MEMORANDUM

FILE NO.: SMP2014 0001

PROPOSAL: Preliminary Plat approval for a Major Subdivision of three lots to nine lots at the southeast corner of Sherwood Lane and Glacier Highway.

SHEET 1 OF 1
DATE: MARCH 6, 2014
SCALE: 1" = 40'
DINWIDDIE: ANDSOHN ASSOCIATES, LLC
R&W ENGINEERING, INC.
6505 GLACIER HIGHWAY
JUNEAU, ALASKA 99801

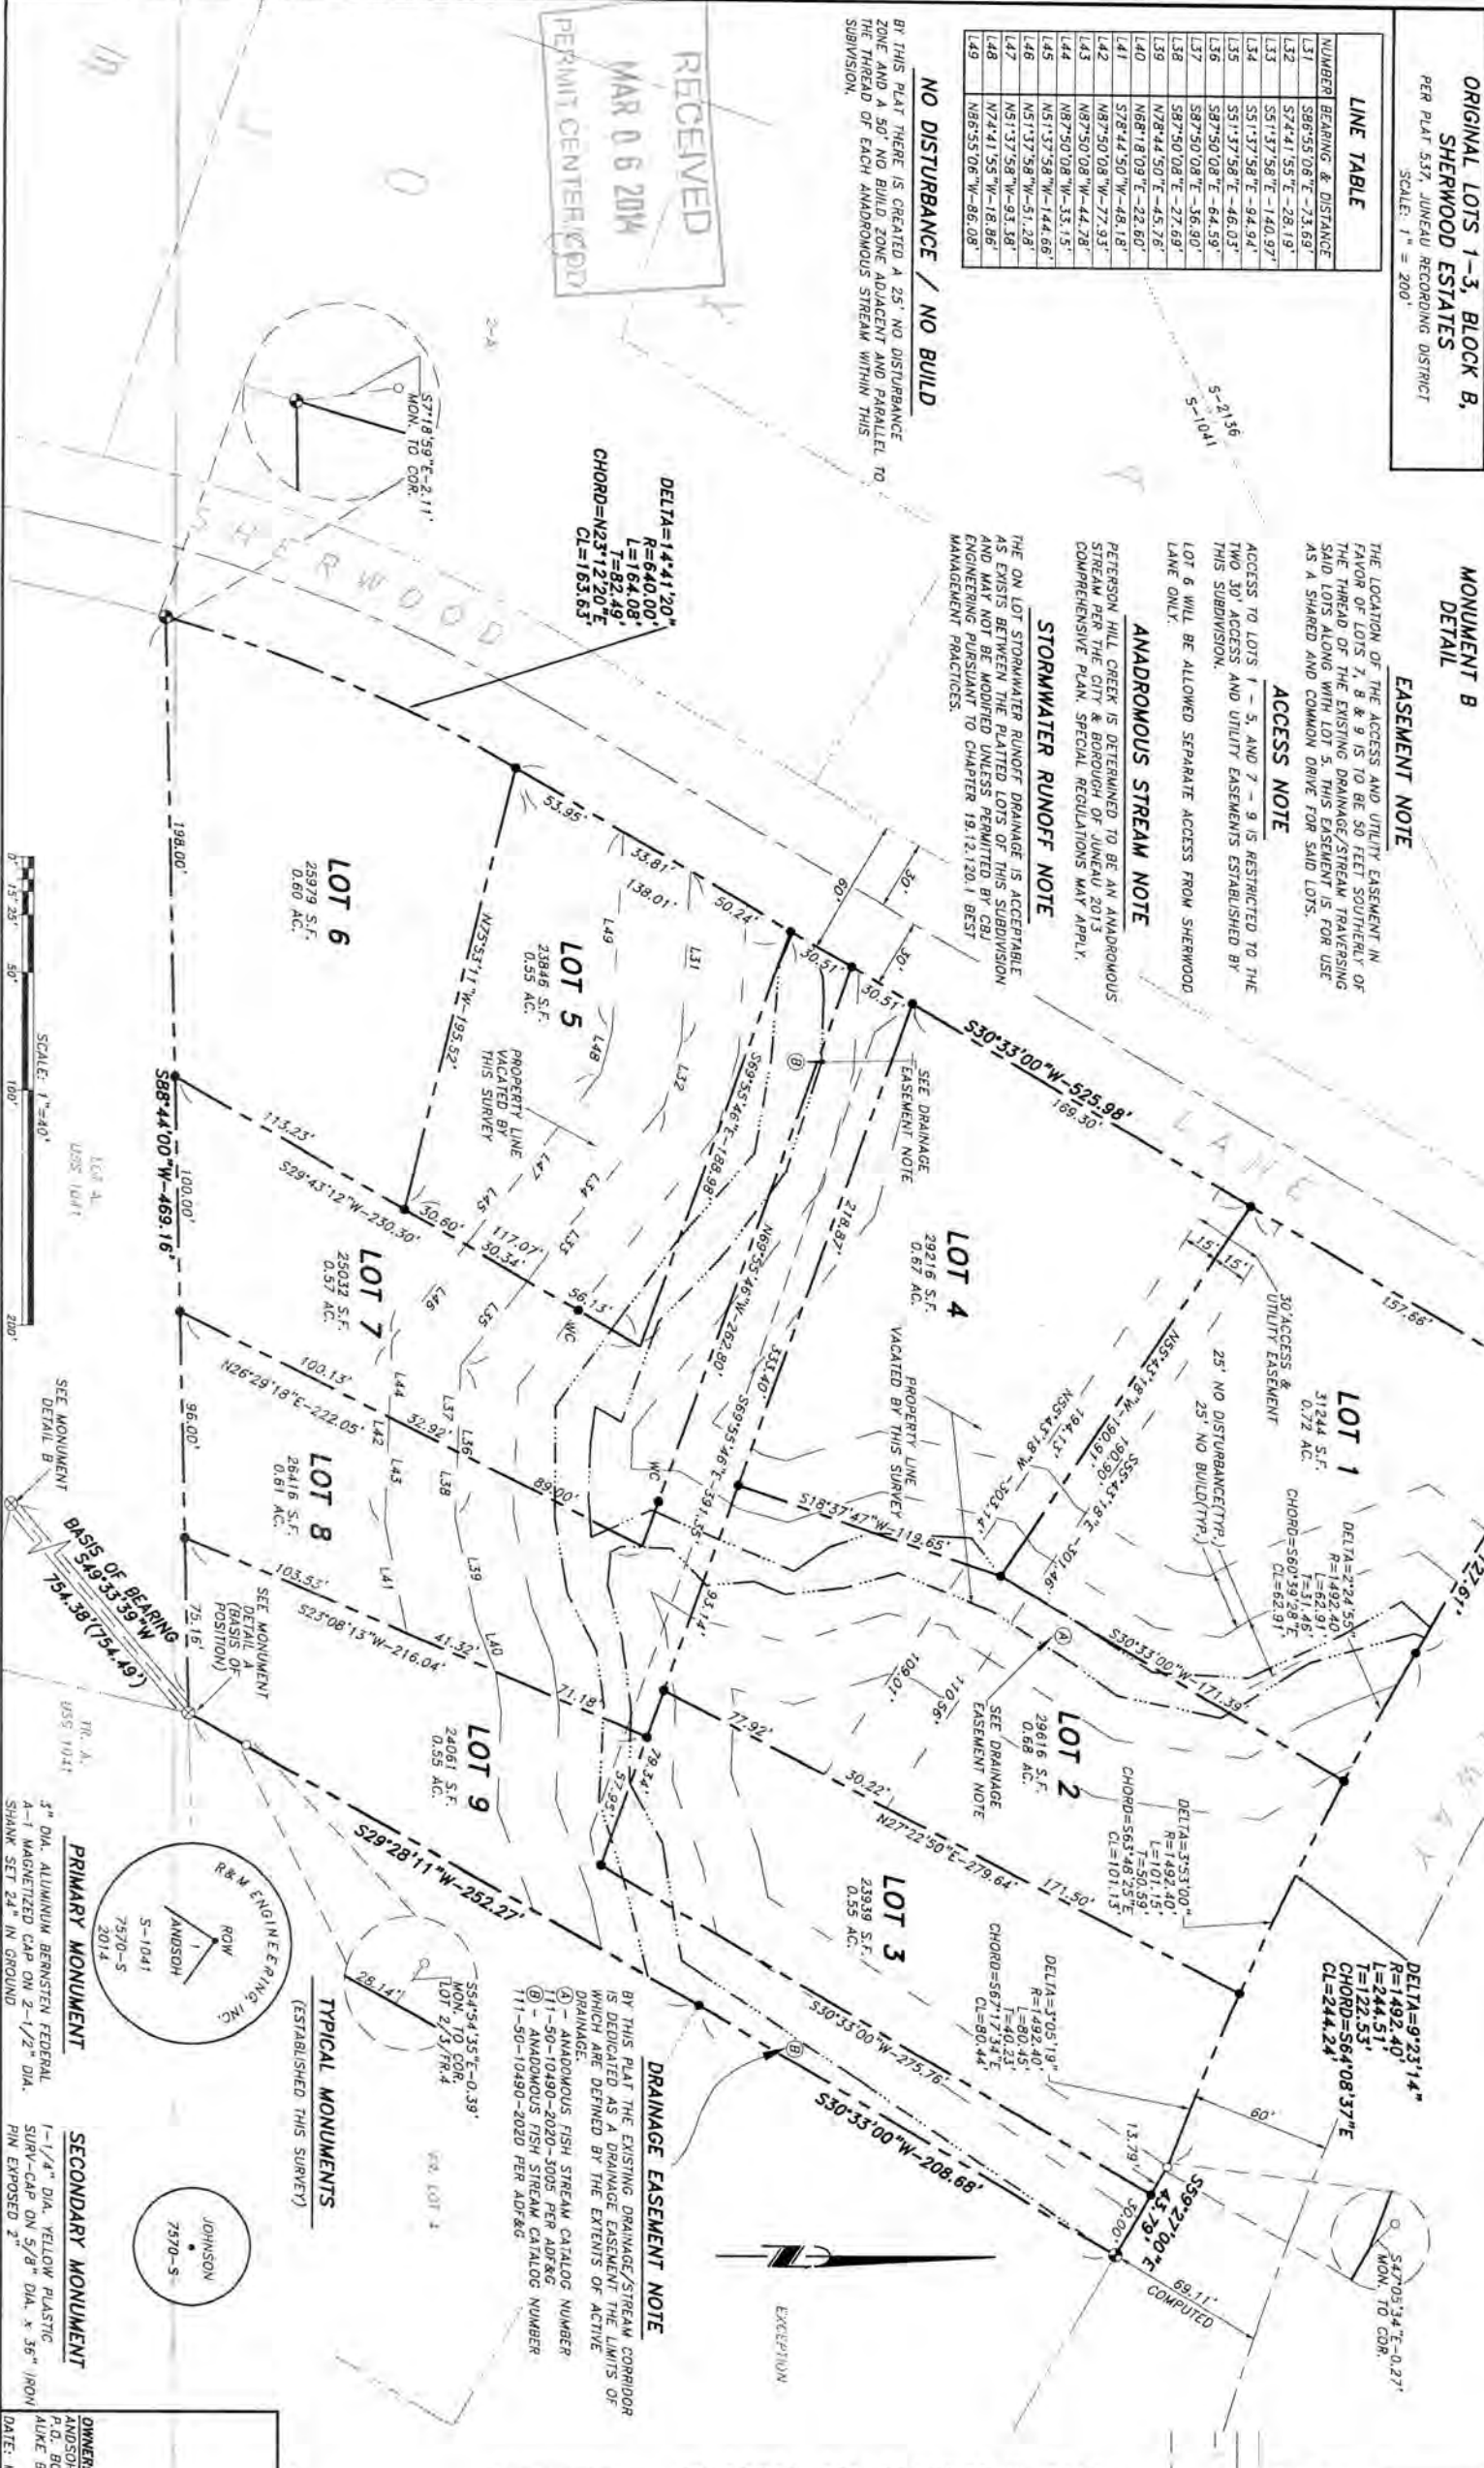
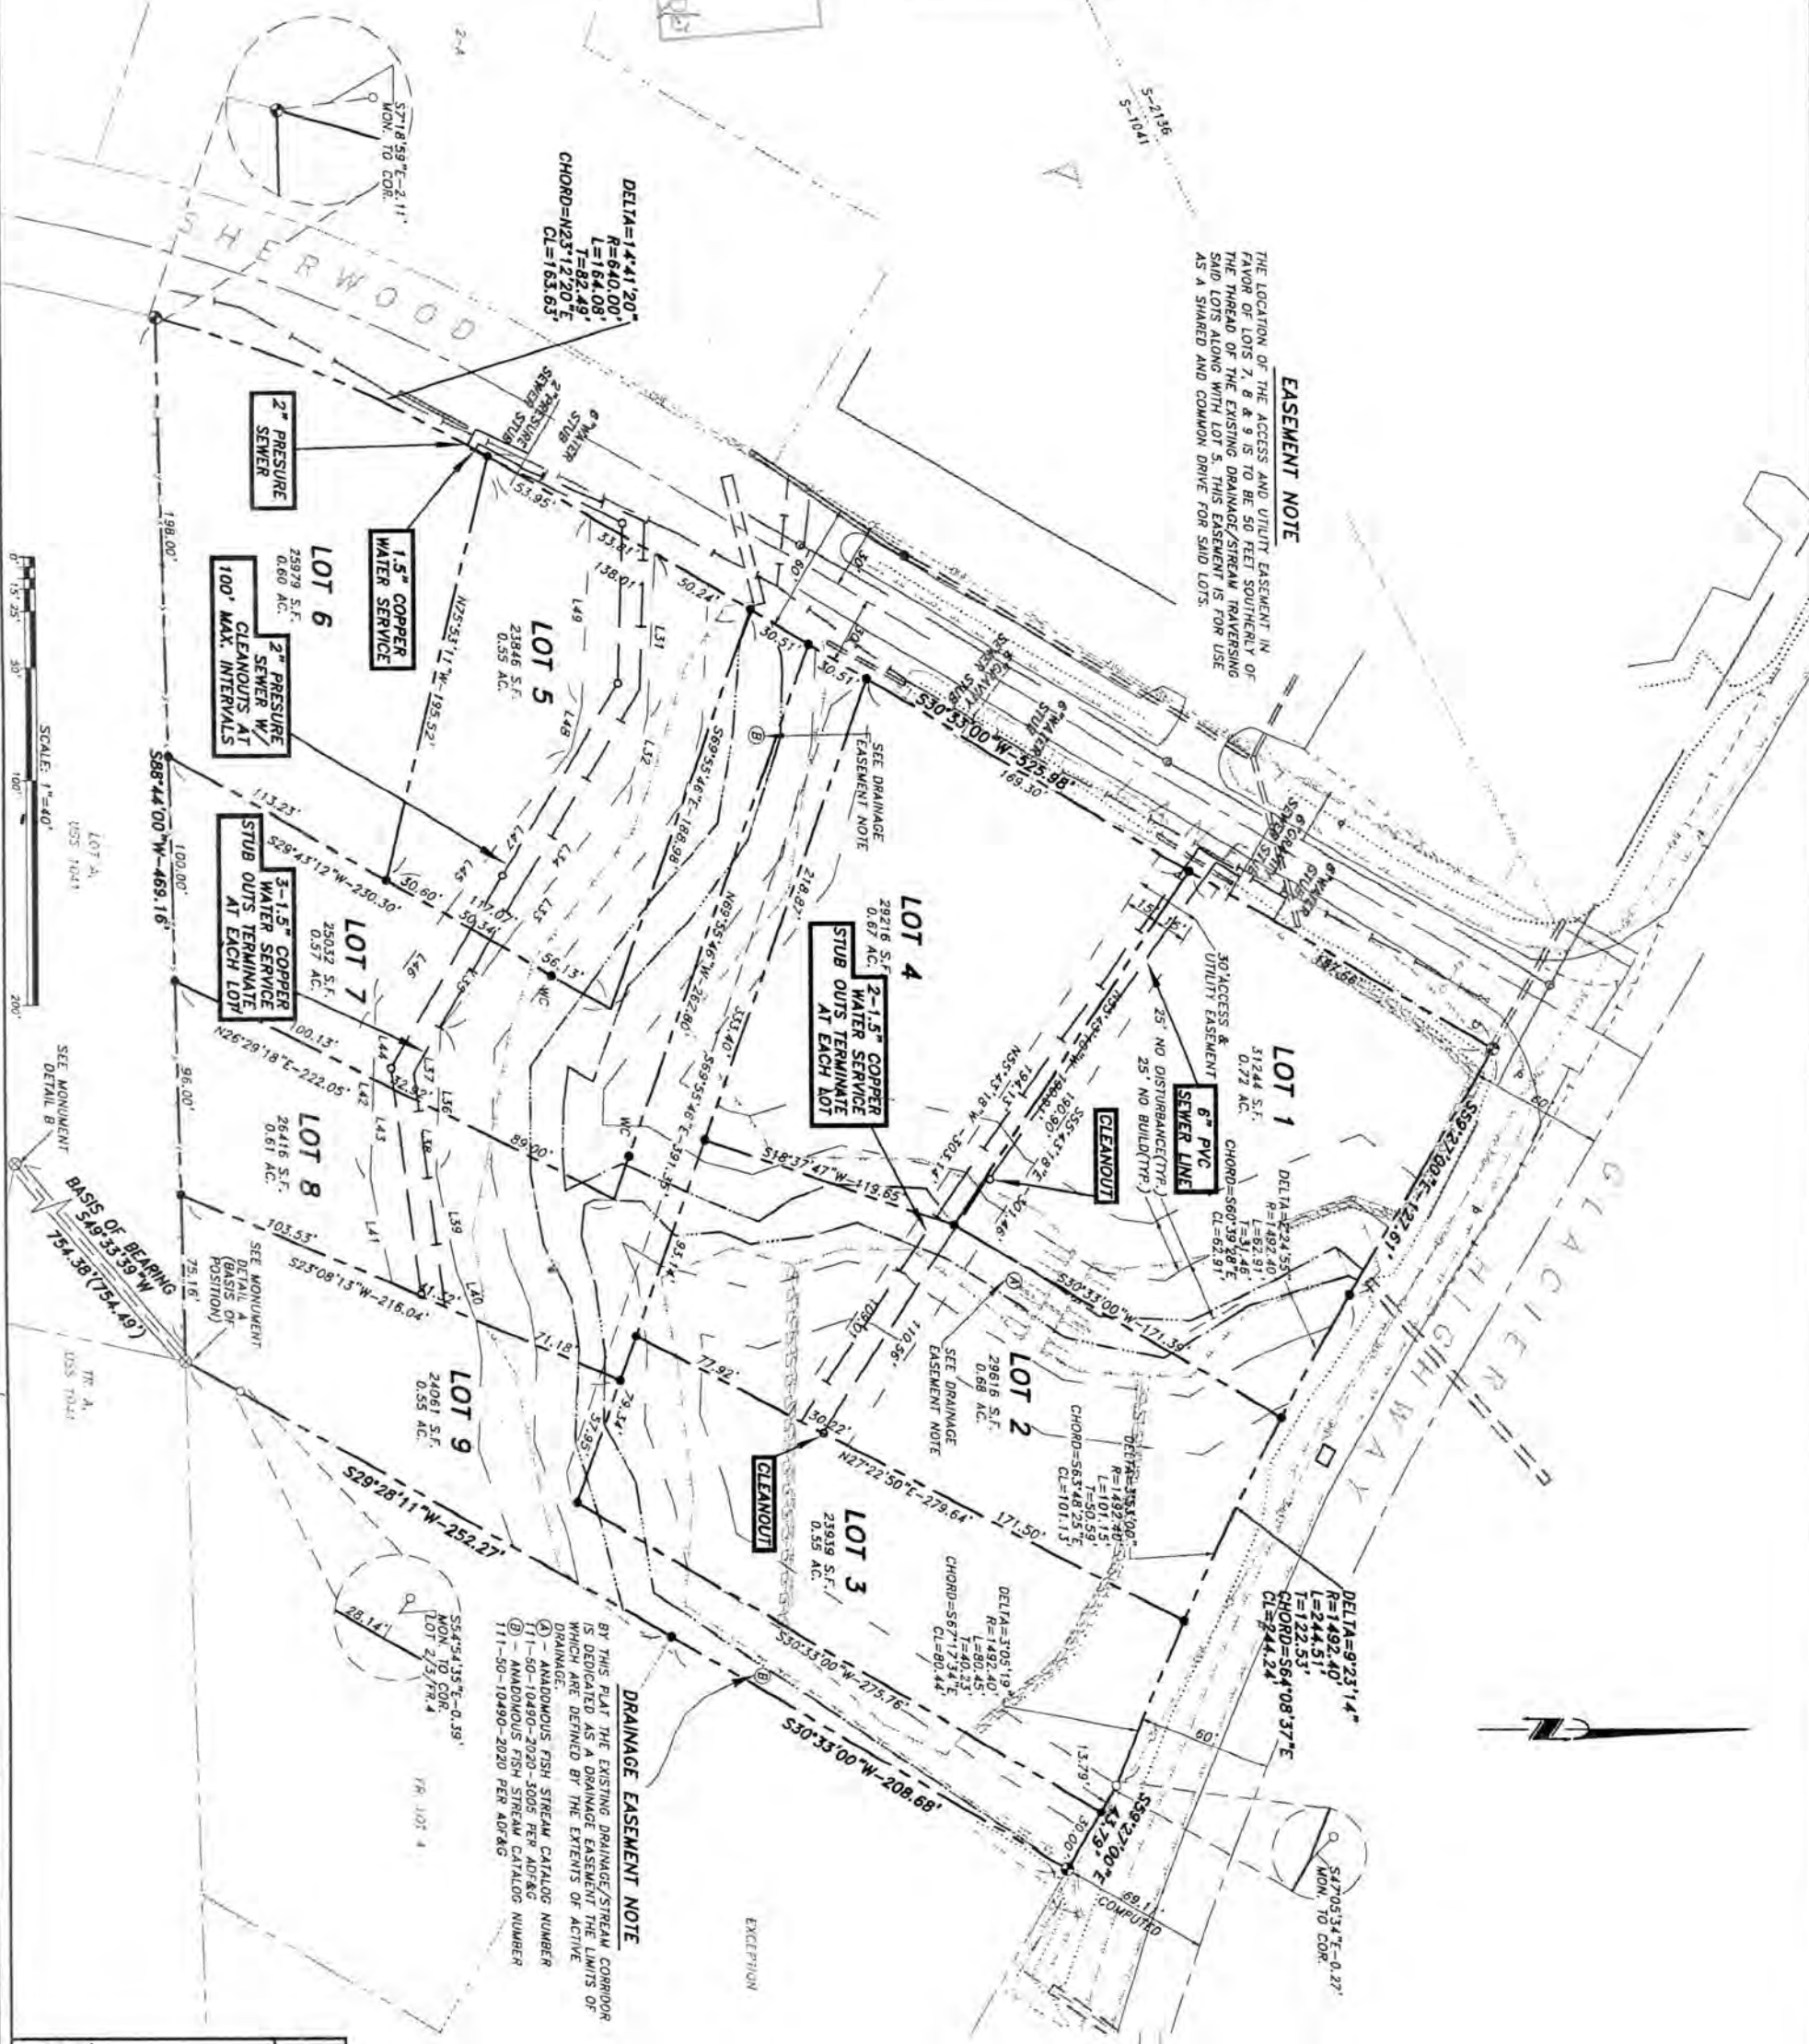
Also, the final plat will need some sort of plat note stating that the area has an anadromous stream (maybe streams) and the 50-foot setback would apply. Some years ago we decided against marking the 50-foot setback area on the survey itself, because the Ordinary High Water Mark can change over time.

ANADROMOUS STREAM NOTE
PETERSON HILL CREEK IS DETERMINED TO BE AN ANADROMOUS STREAM PER THE CITY & BOROUGH OF JUNEAU 2013 COMPREHENSIVE PLAN. SPECIAL REGULATIONS MAY APPLY.

STORMWATER RUNOFF NOTE
THE ON LOT STORMWATER RUNOFF DRAINAGE IS ACCEPTABLE AS EXISTING BETWEEN THE PLATTED LOTS OF THIS SUBDIVISION AND MAY NOT BE MODIFIED UNLESS PERMITTED BY CBJ ENGINEERING PURSUANT TO CHAPTER 19.12.01 BEST MANAGEMENT PRACTICES.
